Westinghouse Class 3

Thimble Reduction Study for
Turkey Point Units 3 and 4
Addendum No. 1

Introduction

Figure 1

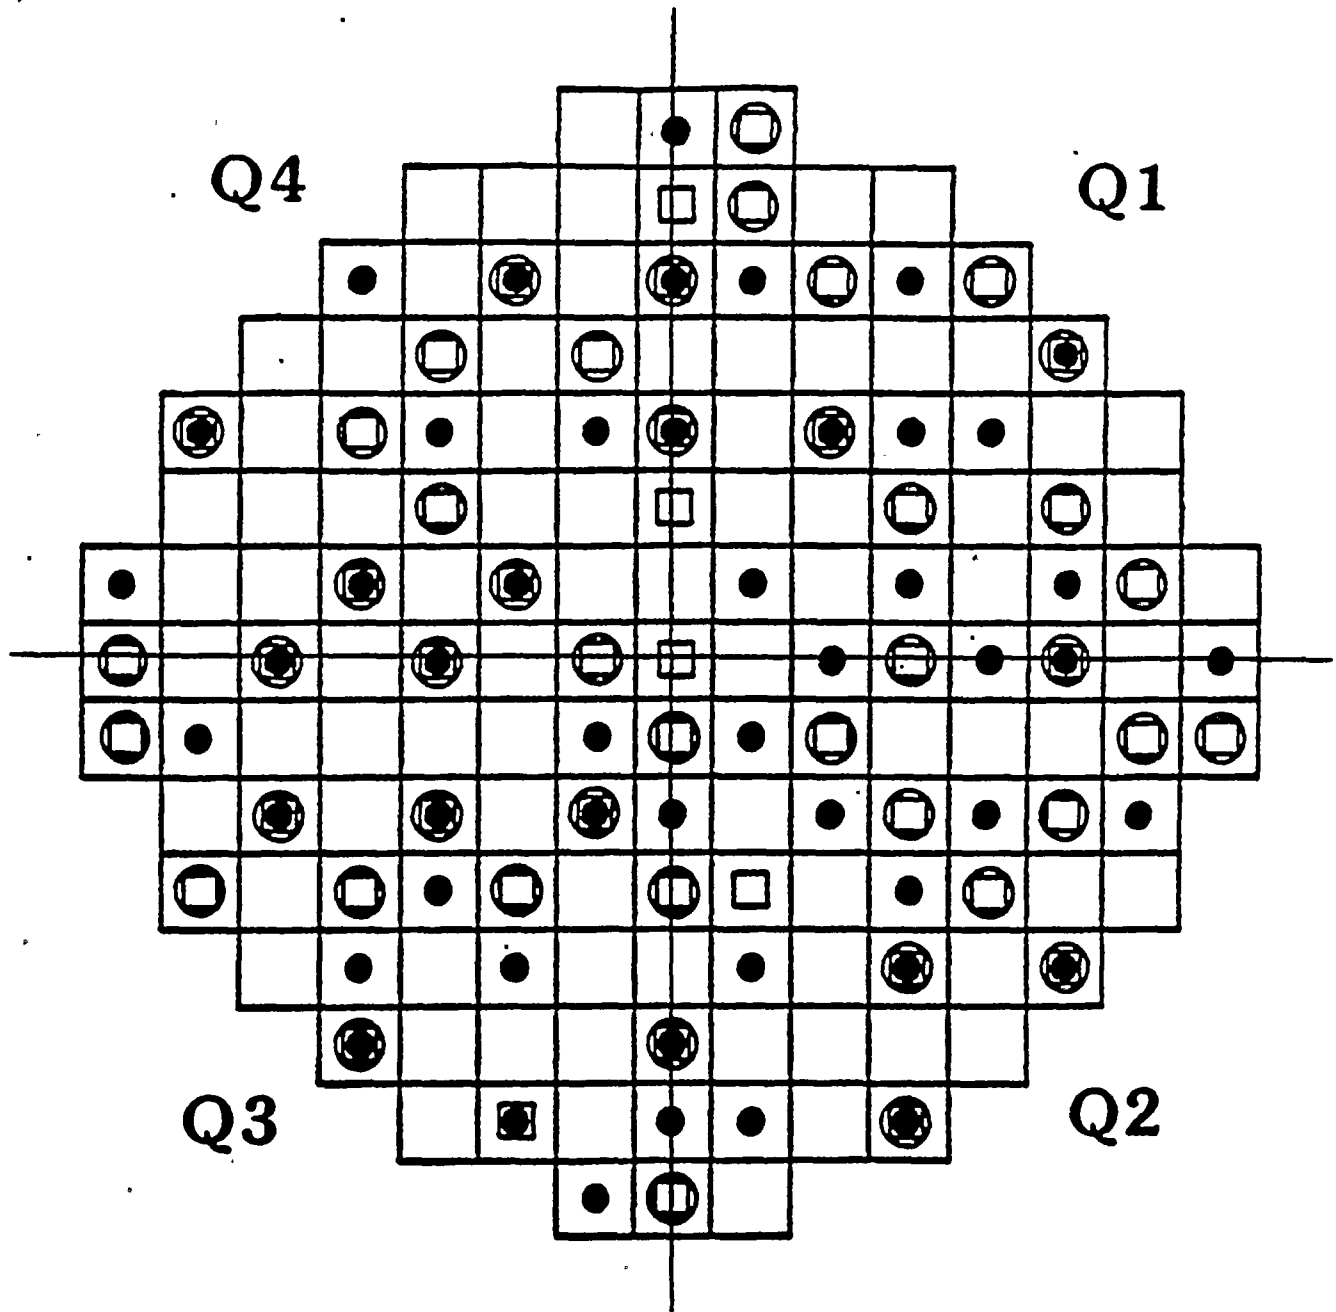
In Reference 2 the core was divided into two sets of quadrants. Thimbles were deleted at random and the minimum number of thimbles left in any one quadrant was determined. Quadrants are defined as they were in Reference 2 (see Figures 1 and 2). For this study, 10-path devices will eliminate the first portion of thimbles and thimbles will then be removed at random until 60% or 50% remain. Therefore, four separate cases must be examined:
